SERVICE BULLETIN

NUMBER: 16-112-18R

SUBJECT: Ignition Key Sticking / Design Change to CVT Shifter / Selector Lever Components / **Parking-Range Switch Warranty Extension**

For Legacy and Outback:

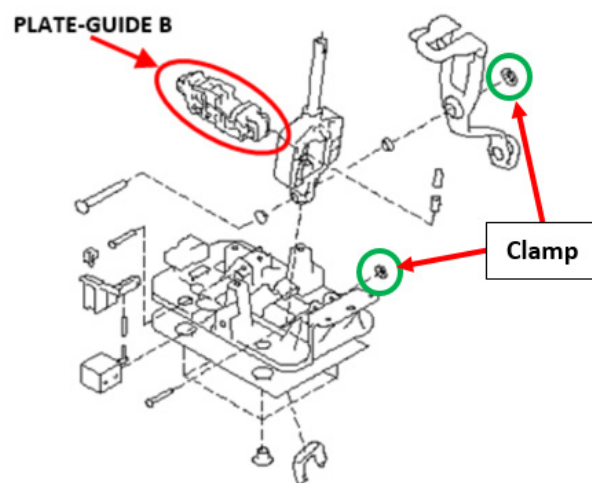
- For **Legacy and Outback**, the shifter assembly (SELECT LEVER COMPLETE) must be replaced if the Park-Range switch is found to be faulty.

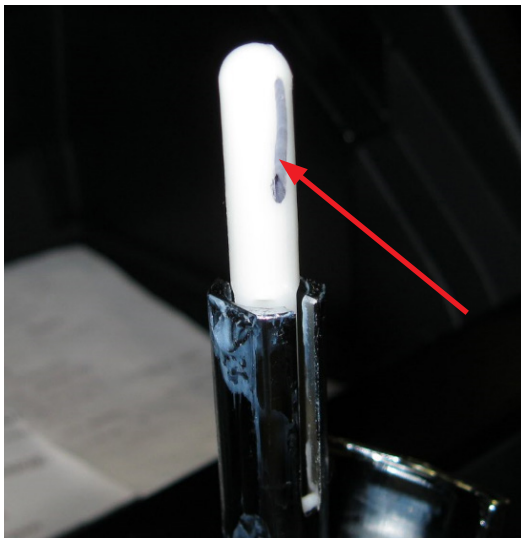
IMPORTANT TIP: After removing the shift knob there will be a white plastic rod / plunger protruding from the top of the chrome lever. Use a permanent marker and mark its position as shown in the photo so it can be put back in the same place during reassembly. The bottom end has a notch in it which **must** be in the correct position for proper operation of the mechanism.
